Comments by Lilian on the alignment

Howard Matis
December 1, 2011

Ladder 16

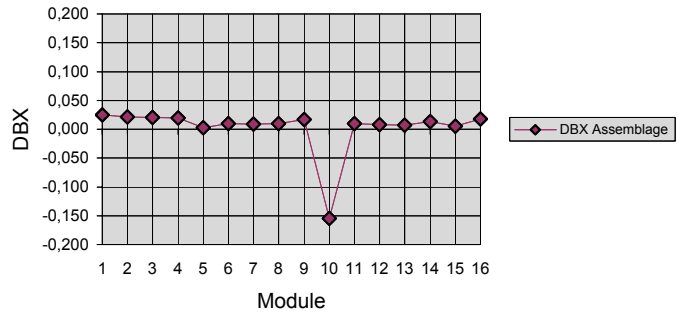
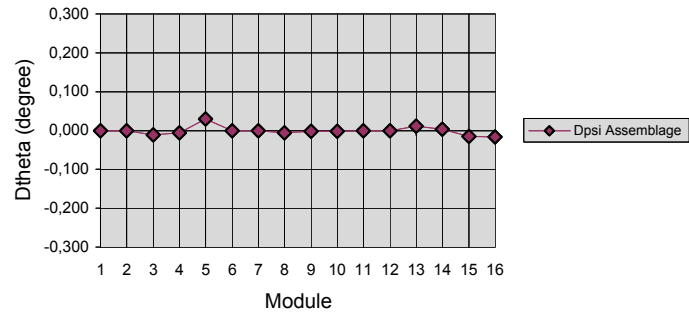
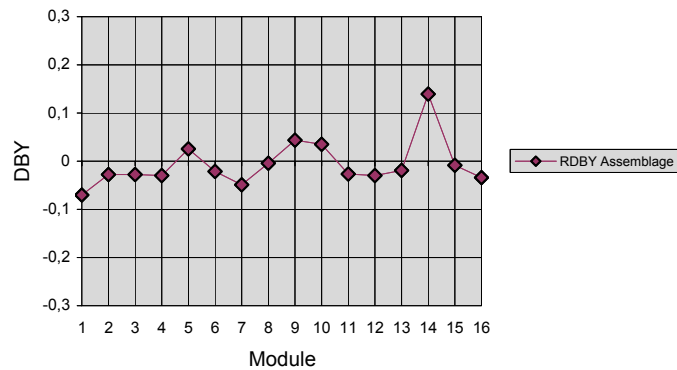
Module 1 not measured (position taken when the module was installed on the bench)
 Module 14 shifted by 400 microns in Y (?)

- This ladder shows two particular defects
 - Module 10 is shifted by 150 μm in X
 - The position of the modules is irregular in Y with a maximum shift of 140 μm for module 14.
- Must correct for individual modules
 - In the X direction 20 μm is expected

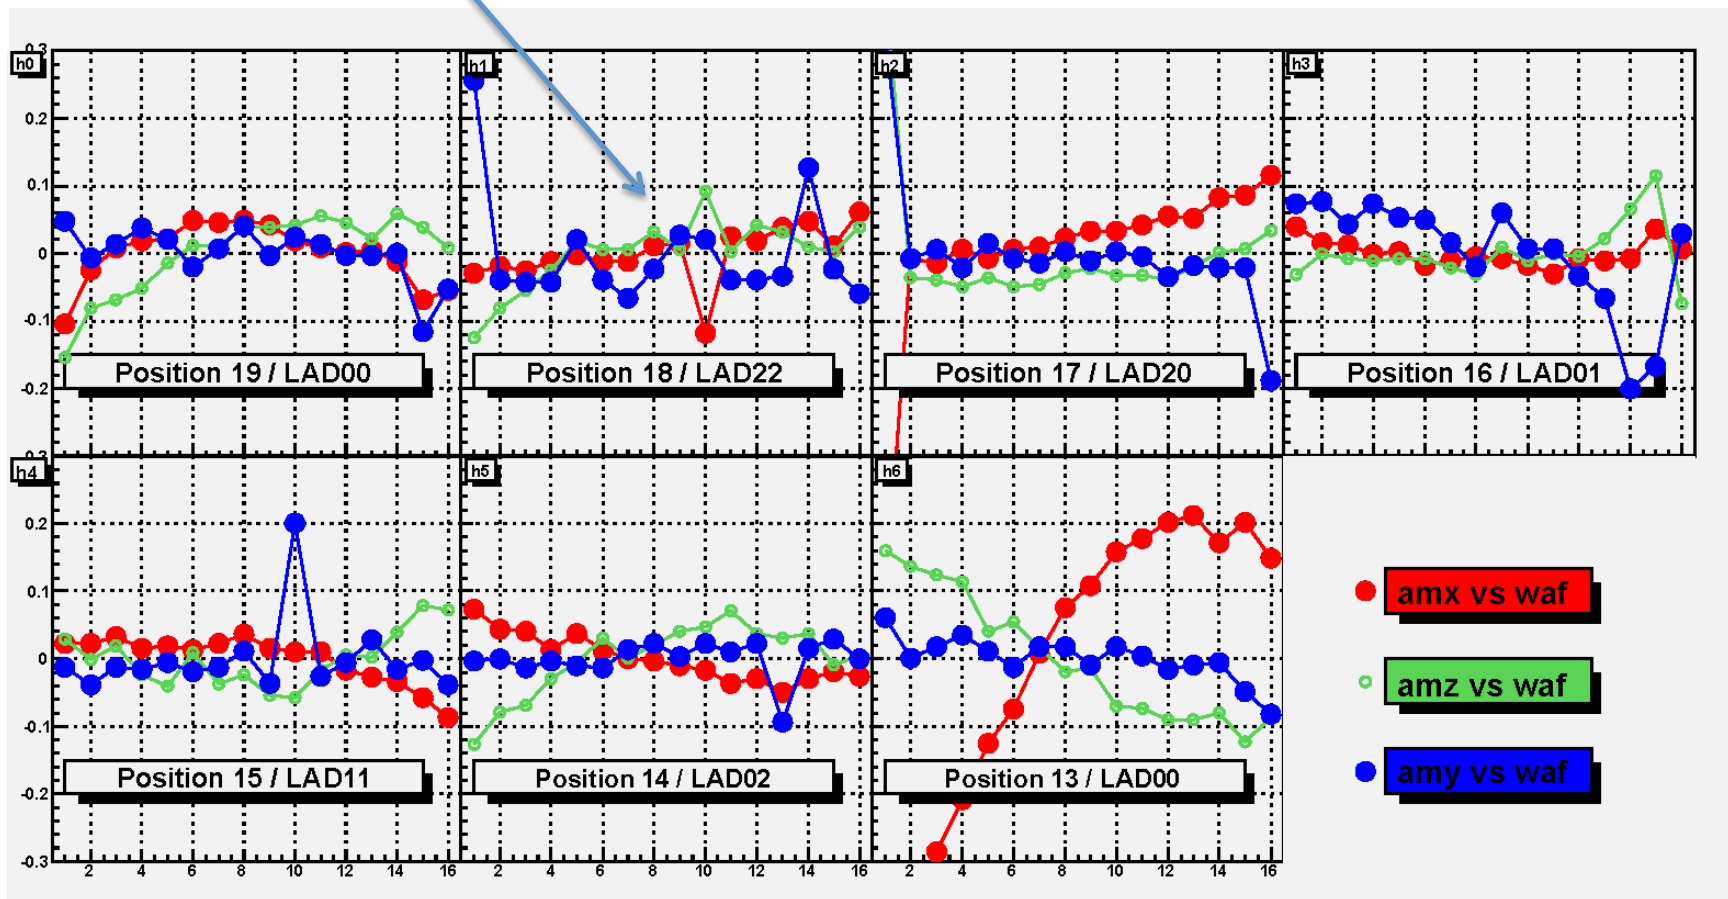
Ladder 22 – Looks different from before
